33521B-03

Modification Recommended Service Note

33500 Series Waveform Generator

Serial Numbers: MY50000000-MY57701111/ SG50000000-SG57700609

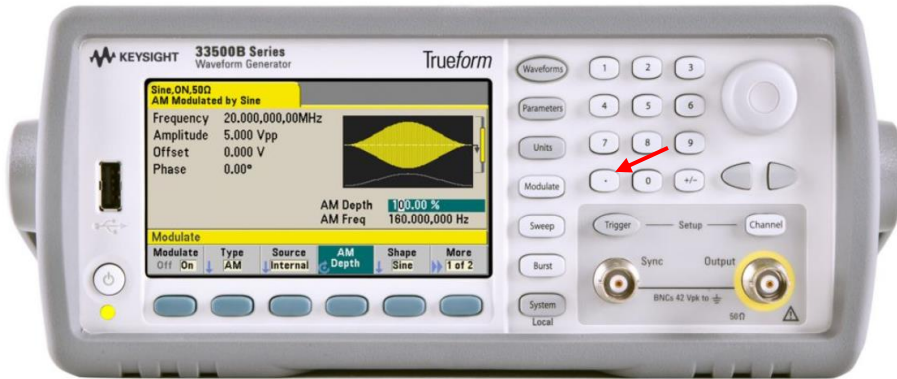
The Problem – The dot key  on front panel intermittently not active.

User may experience the dot key on the front panel intermittently inactive when pressed.

For units with inactive dot key, please return units back to Service Center for repair.

1. Replace the front panel board (part number: 33500-66308).
2. Turn on the instrument and check if the dot key is active when pressed.
